RE: Keohane Readymix Ltd. – Planning Application for Extraction of Sand & Gravel at Knockroe, Bandon, Co. Cork.

Planning Ref. 25/04666 - Further Information Response

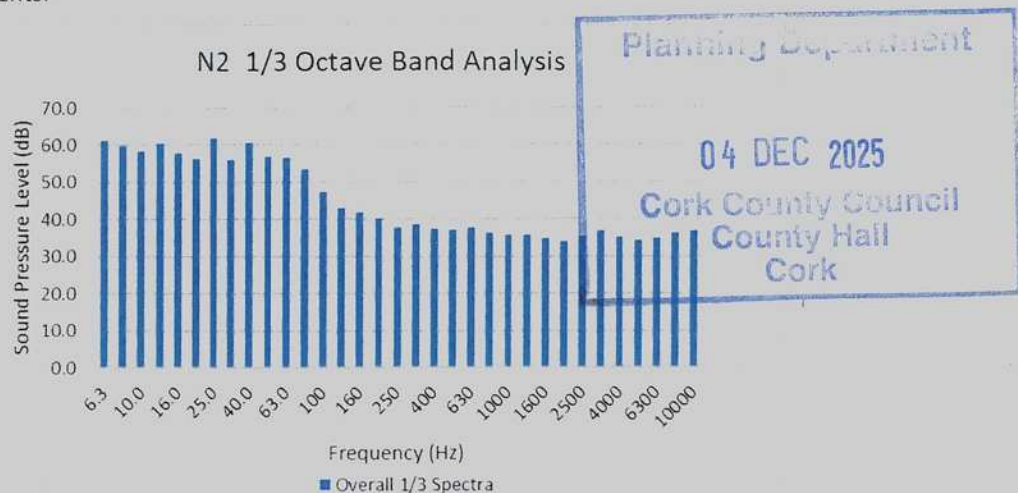
It is noted from the submission that “the machinery used at the proposed site will not generate impulsive or tonal noise”. This should be further expanded and detailed with any supporting documentation to support same submitted.

tonal component to be present the level difference of adjacent bands should be greater than or equal to the following values in both adjacent one-third-octave bands:

- 15dB in low-frequency one-third-octave bands (25Hz to 125Hz);
- 8dB in middle-frequency bands (160Hz to 400Hz), and;
- 5dB in high-frequency bands (500Hz to 10,000Hz).

A typical 1/3 octave band analysis from a site with similar activity (noise sources including loading shovel / excavator and dump truck for soil stripping, extraction of sand & gravel) is provided below. Applying the criteria above, this confirms that the proposed activities on site with similar machinery will not give rise to tonal noise components.

The machinery used at the proposed site will not generate impulsive or tonal noise, no penalty was therefore applied to the predicted operational LAr, 1hr noise level for presence of tonal or impulsive elements or for prediction of resultant noise level at each receptor.
